To: Planning Commission

From: Public Member Crystal Chaix (neighbor)

Subject: Questions, comments and concerns regarding Agenda item 4 on the November 12, 2025, Planning Commission Meeting

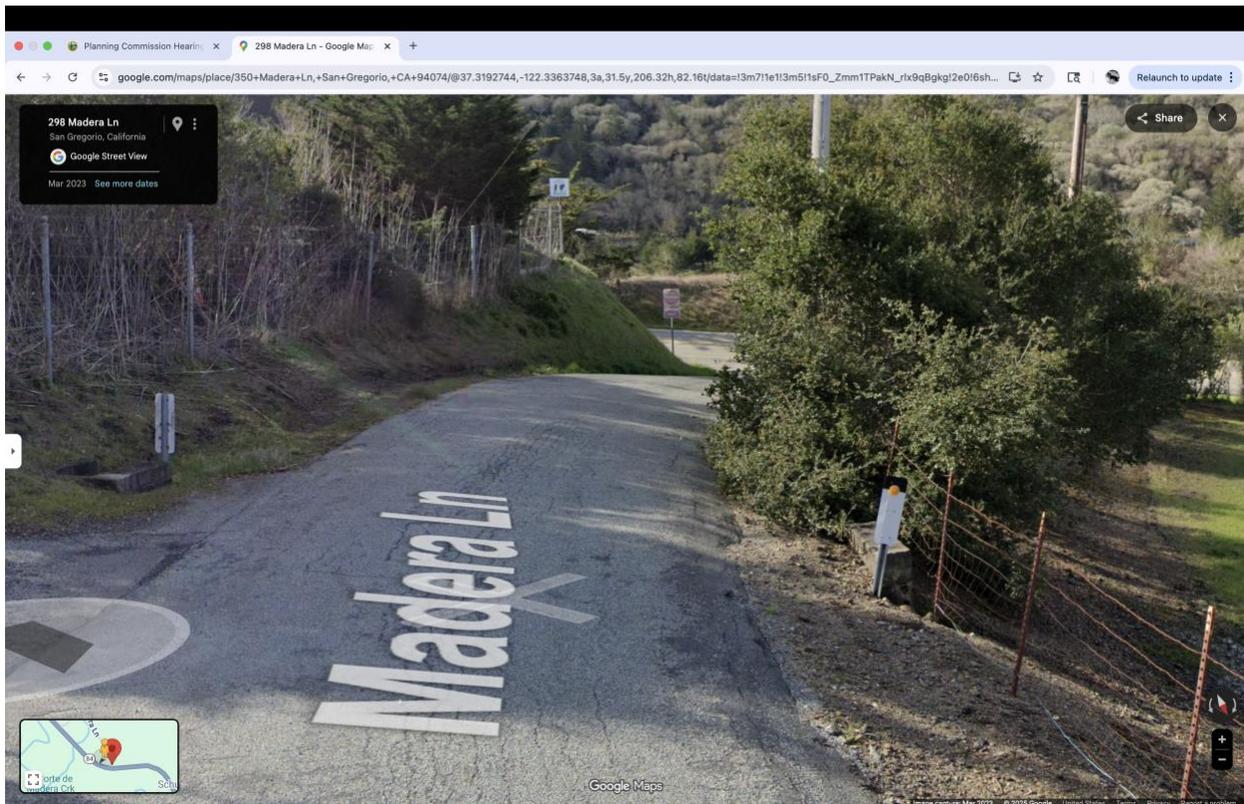
Looking at the photo below, you will see that the runoff flows west down the applicant’s driveway and into the ditch. The ditch has a concrete culvert that runs under Madera Lane with the outlet flowing into my crop of hay.

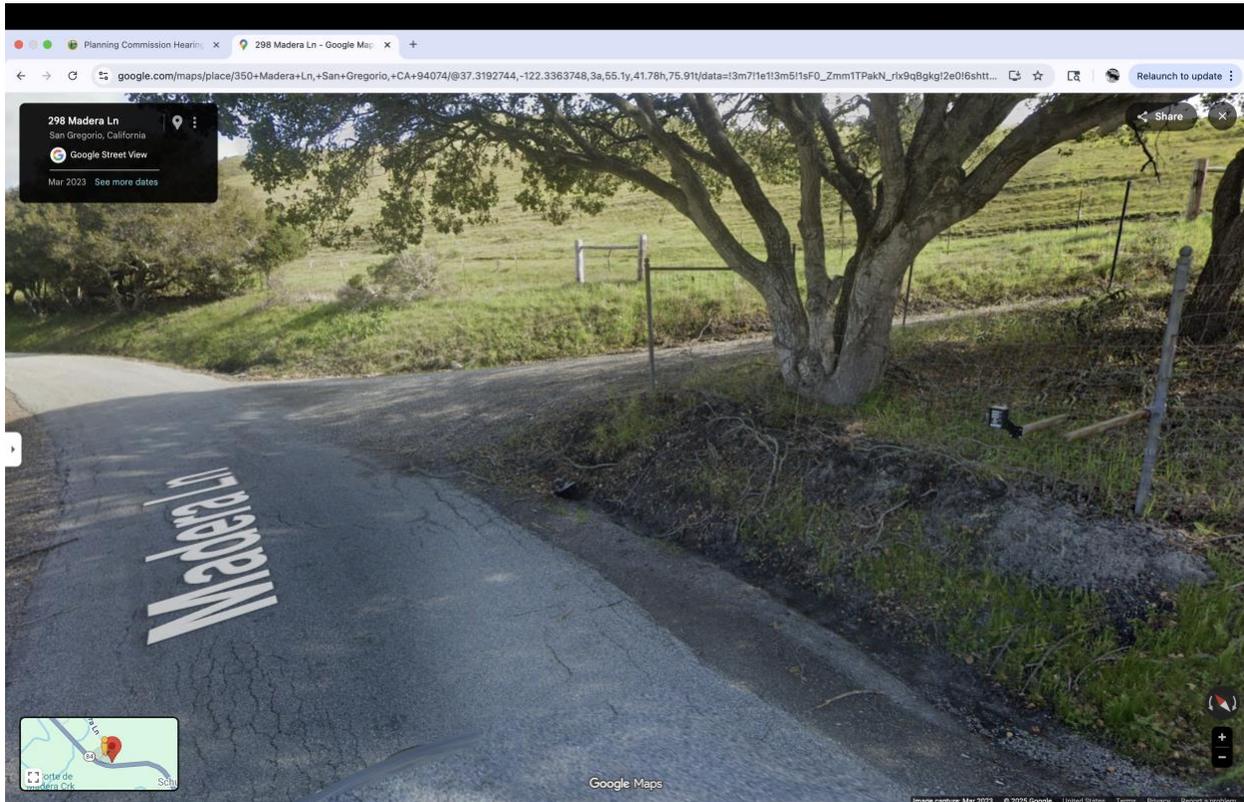
On the other side of the driveway, there is a culvert that runs along Madera Lane to the west. It too flows into a culvert and flows into the Corde Madera Creek.
